MEMORANDUM

UTAH DEPARTMENT OF TRANSPORTATION

SUBJECT: Standards Committee Meeting Minutes and Next Meeting

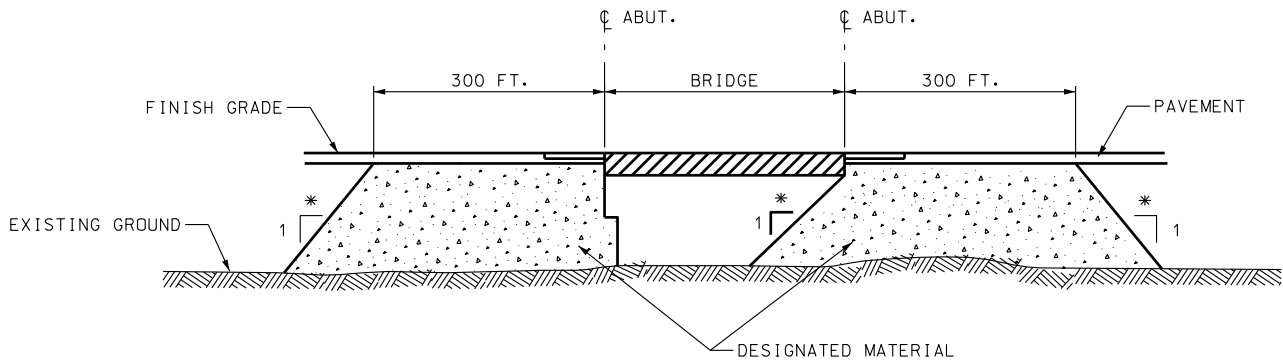
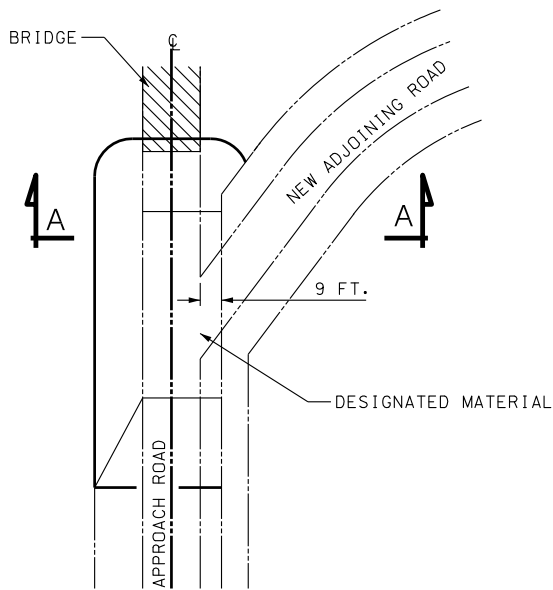
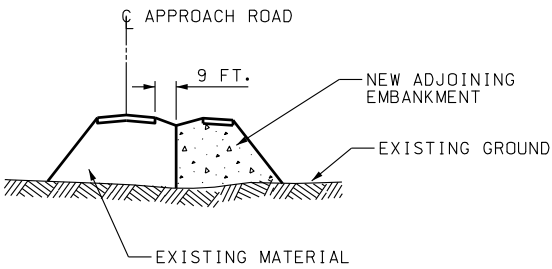
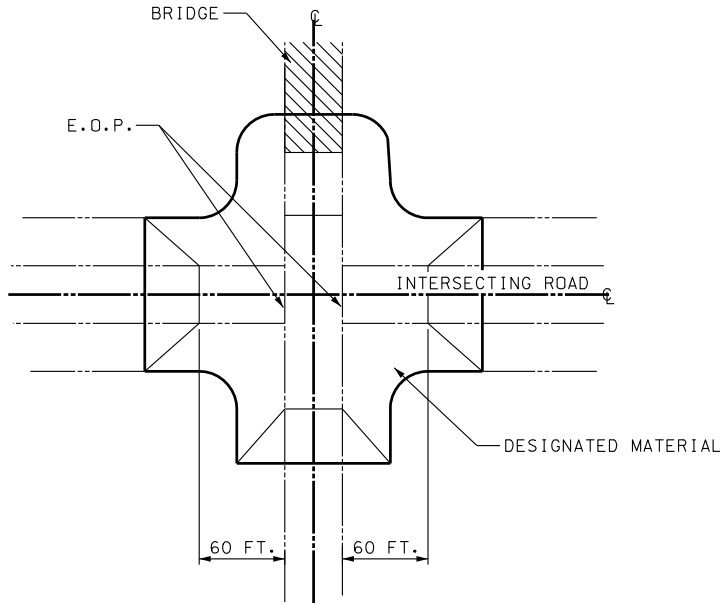
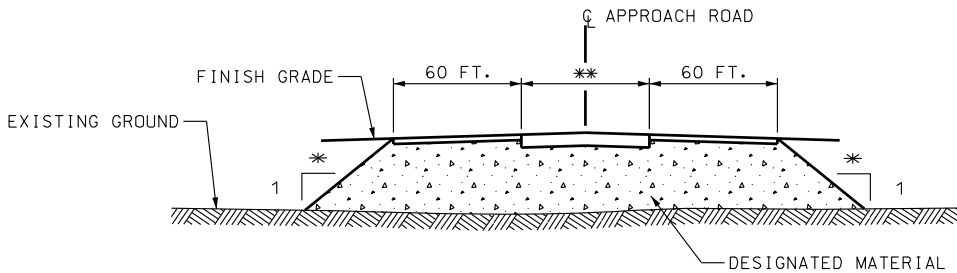
- During the construction process there has been confusion with were the limits for Embankment for Bridge should be placed. The proposed drawing DD-16 sets the limits of placement for three scenarios approach embankments, adjoining embankments, and intersection roadway embankments.**

(DEER BARRIER)
RIGHT OF WAY FENCE
TYPE G

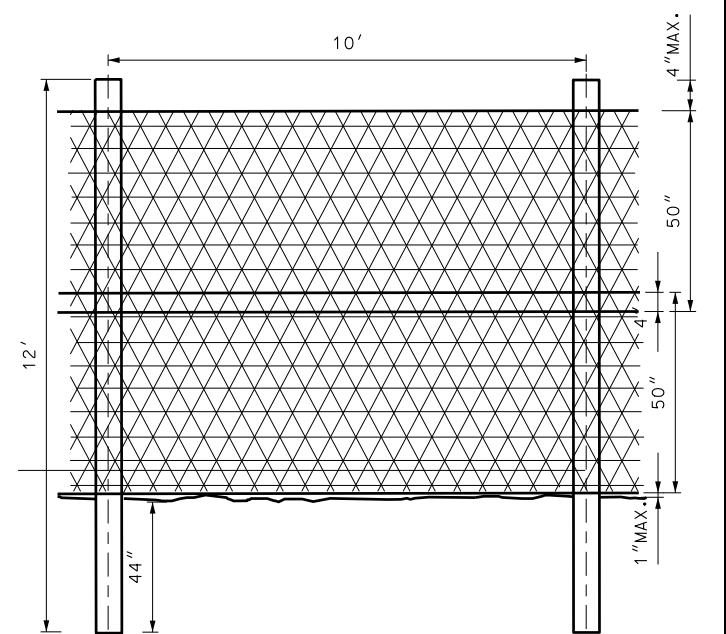
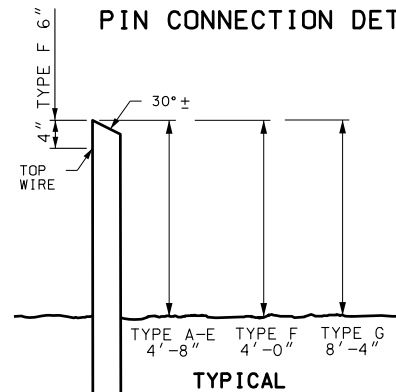
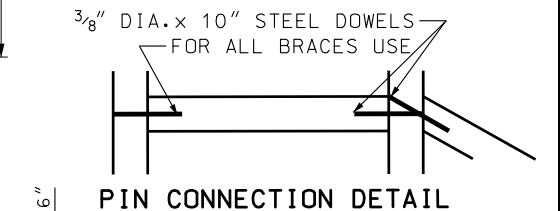
On Fig 1A for the typical for the type G deer barrier, notes 1 and 2 say "lap the 50 inches by 4 inches." It sounds awkward to me. It might sound better to say "lap the 50 inch mesh by 4 inches." This isn't critical but may clarify things some.

Sheet FG 1A Typical detail above Type G fence detail.

I do not feel the 1" gap at the bottom of the fence is realistic. Deer fence does not usually go on easy or smooth terrain. Are you planning on having the contractor grade between line posts to achieve this? This will increase the environmental impacts. If not then the contractor will have to place many tie down rocks as shown on sheet FG 1B Typical sag detail. This is going to substantially increase the cost of installing deer fence. The contractor will still need to do some grading to achieve the 1" limitation.

Dwg FG 1A Type G fence note 3 - replace "THEN" with "THAN"

Dwg FG 1A Type F fence - replace the barbed wire symbol for the top wire with plain wire. Change wire to ground distance to 1" to match rationale for bottom of fabric on type G fence

STD DWG
GW 5A

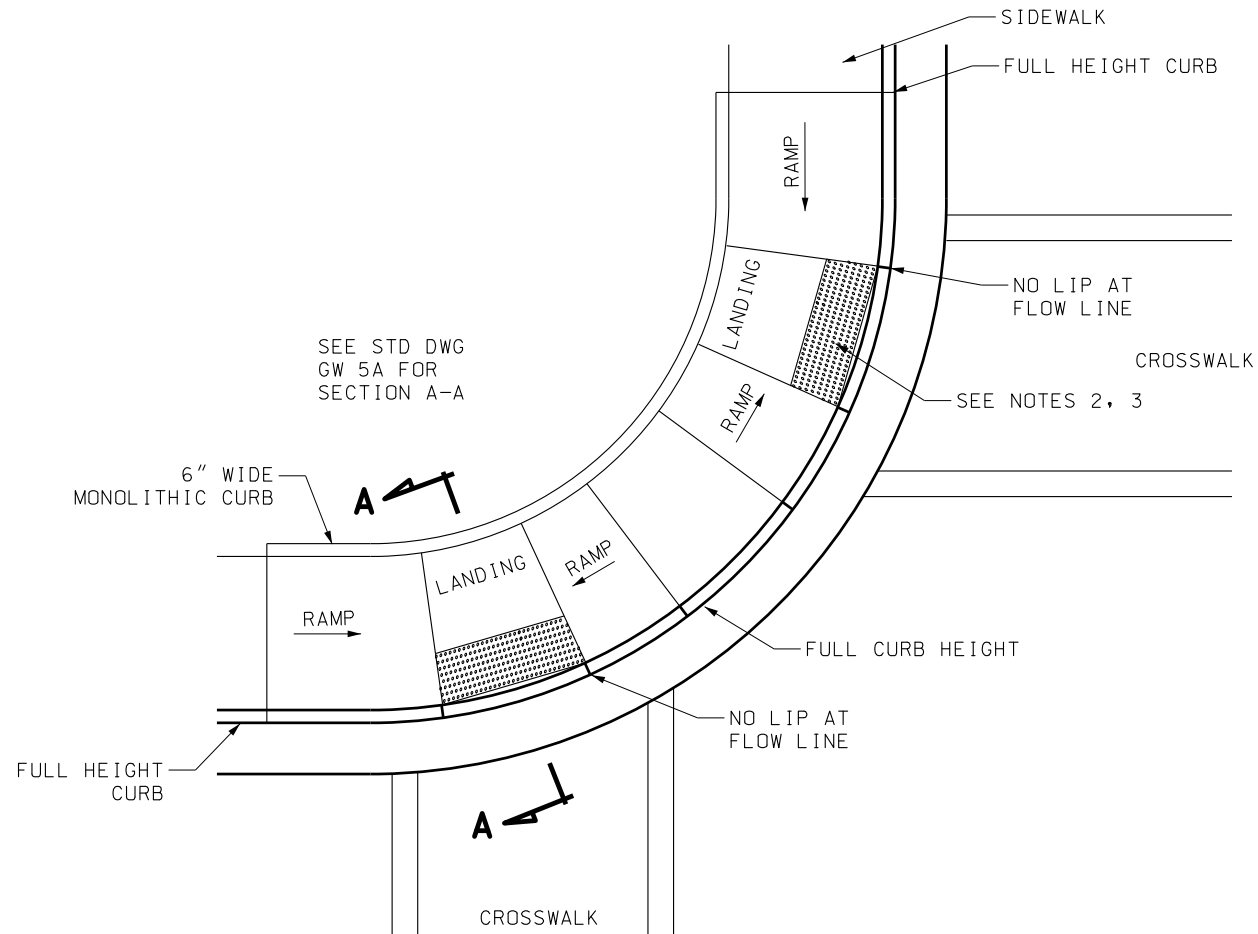
Consolidated NOTES as GENERAL NOTES on Drawing GW 5A. Arranged notes so that notes repeated on GW 5B and GW 5C are numbered the same as on GW 5A.

Standard Drawing/Specification Review Sheet		Review Comments		
Std Dwg/Spec Number	PV 8, Rumble Strips, Centerline Application	Sheet 1	of	1
Date:	April 9, 2007	Facilitator:	John Leonard

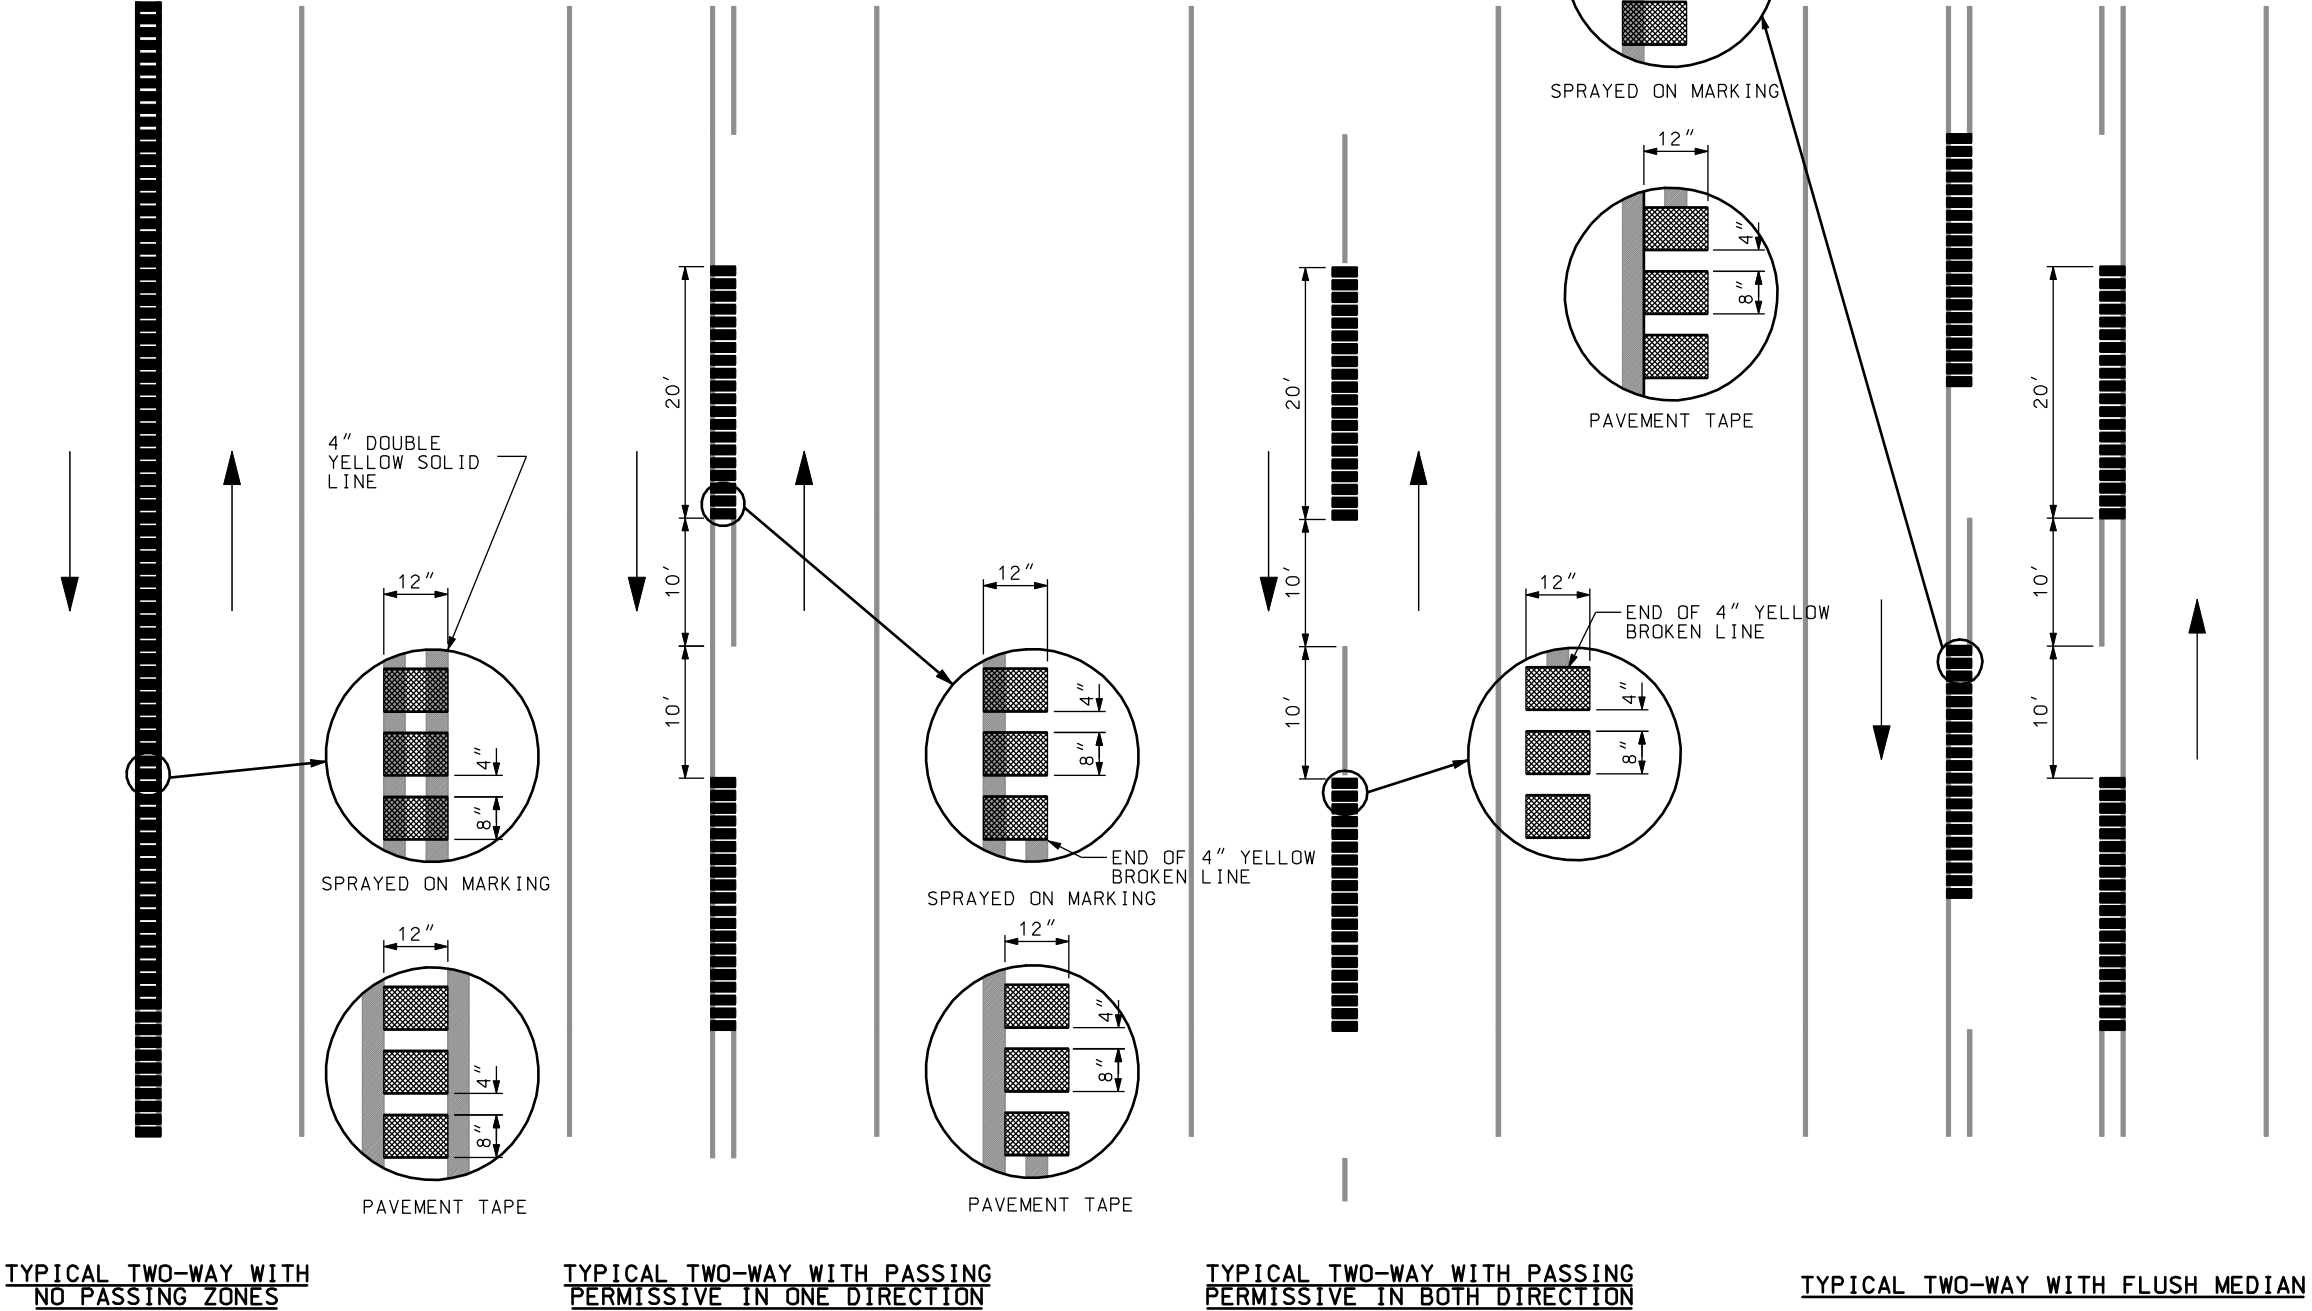
This drawing was reviewed with and endorsed by the Traffic Engineering Panel. Maintenance from Region One was contacted about their experience with similar style of rumble strips in a median application (Sardine Canyon) and have not expressed any concerns about the maintenance of this design. It is a similar construction technique to the one used for the installation of shoulder rumble strips used throughout the State (and referenced in STD DWGs PV-6 and PV-7). Materials has the continuing concern about any impact to the pavement surfacing by grinding away a small portion of the surface. Flush coating of the strips after milling is required to seal the surface disturbed by the grinding operation.

DETAIL TC 2A-1

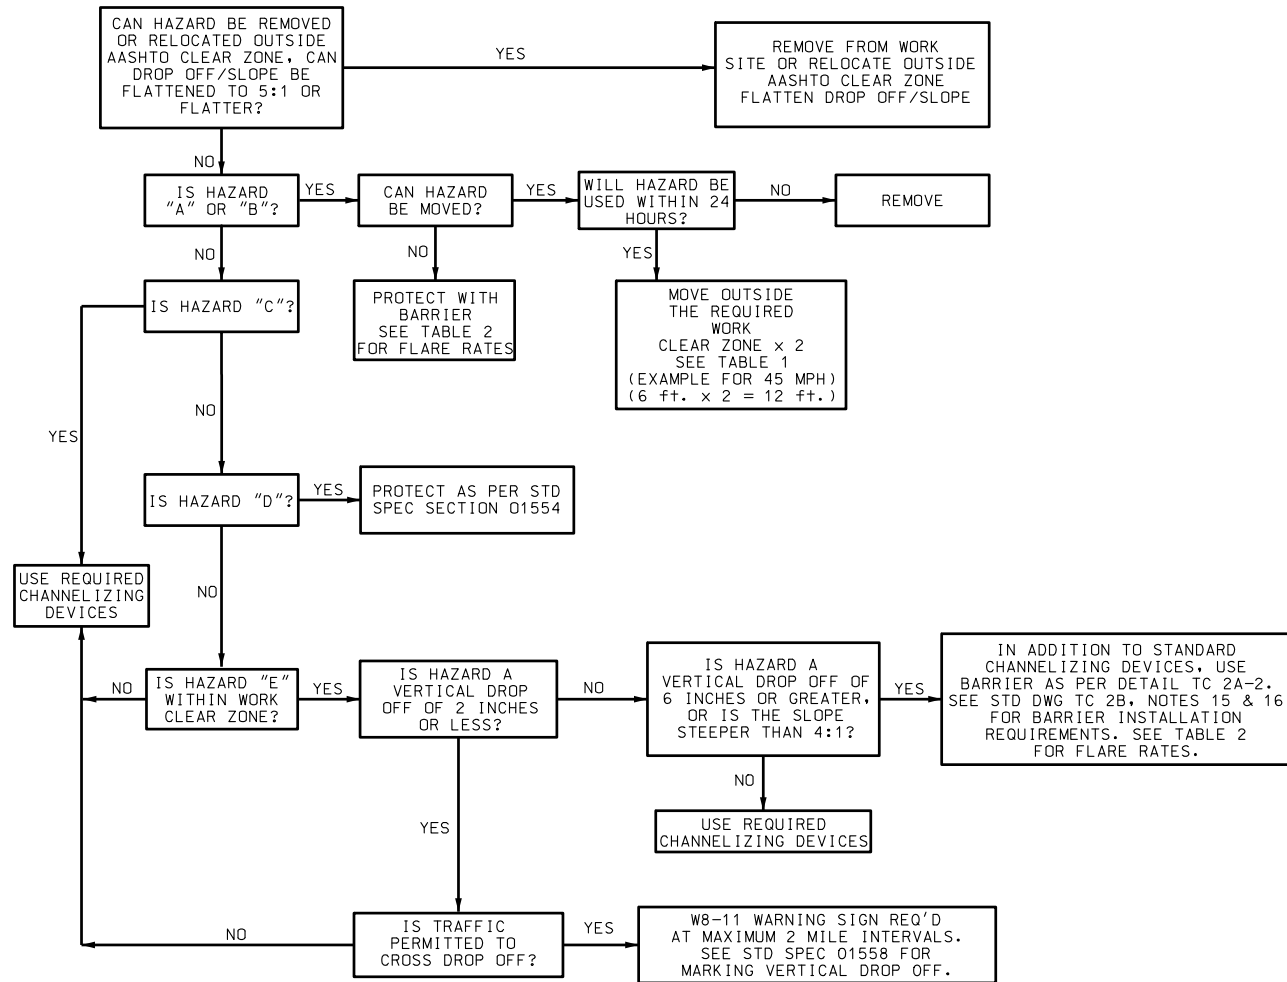
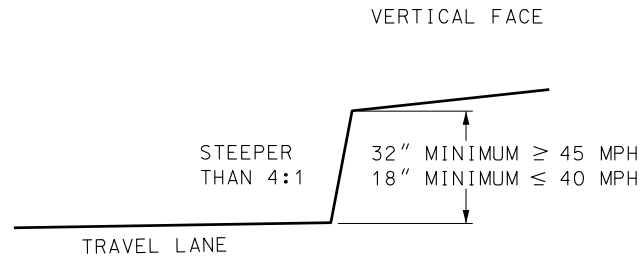
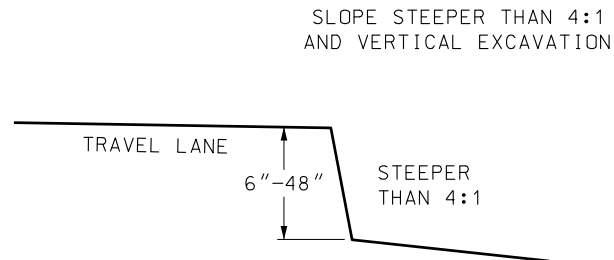
Item No.	Reviewer	Sheet/Section No.	Comment	Review Mtg. Action	Final Action.
18	Anne Ogden, R-4 Traffic	TC 2A	--Line "1" in Detail TC 2A-1 - Maybe reword to say "Use detail TC 2A-1 and Table 1 (Work Clear Zone) when mitigating..."	A	A
			--Line 1.D in Detail TC 2A-1 - Use "I.E." instead of "IE:"	A	A
			--"Article 1.6F" and "Article 3.1D" are actually "paragraphs" - Maybe show as "Paragraph 1.6.F" and "Paragraph 3.1.D"	B	C
			--Reorganize text in upper left box ("Remove from work site or relocate outside...") for aesthetics?	A	A
			--Detail TC 2A-2 - Details are slightly confusing...maybe because it's attempting to combine slopes and vertical faces. It's misleading to have the note "Steeper than 4:1" near two lines with different slopes. Where is the 18"-32" or 6"-48" height measured? At the edge of the travel lane for vertical faces? How far from the travel lane for slopes steeper than 4:1?	B	A

1. Modified Hazard Mitigation Chart to reflect current Department Specifications, current AASHTO Roadway Design Guide, and the current MUTCD.
2. Primary modifications to the flow of Hazard "E".
3. Added to bottom of Detail TC-1 drop off definition.
4. Added reference to Specification 01558 3.1d for marking vertical drop off.
5. Moved notes to new standard drawing TC 2B.
6. Added type E vertical drop off hazards detail TC 2A-2
7. Title Hazard Mitigation.

- USE DETAIL TC 2A-1 AND TABLE 1 (WORK CLEAR ZONE) WHEN MITIGATING THE FOLLOWING HAZARDS:
 - NON-WORKING EQUIPMENT OR VEHICLES
 - STOCKPILED MATERIAL
 - WORKING VEHICLES AND WORKERS (NON-FLAGGERS)
 - OTHER OBJECTS AND FEATURES (I.E.: BRIDGE PARAPETS, BARRIER BLUNT ENDS, POLES)
 - SLOPES STEEPER THAN 4:1 OR A VERTICAL DROP OFF* OF LESS THAN 48 INCHES (SEE DETAIL TC 2A-2 FOR EXAMPLES)
- MITIGATE ALL OTHER HAZARDS, SLOPES STEEPER THAN 4:1, OR VERTICAL DROP OFFS* 48 INCHES OR GREATER WITHIN AASHTO CLEAR ZONE AS APPROVED BY THE REGION TRAFFIC ENGINEER.
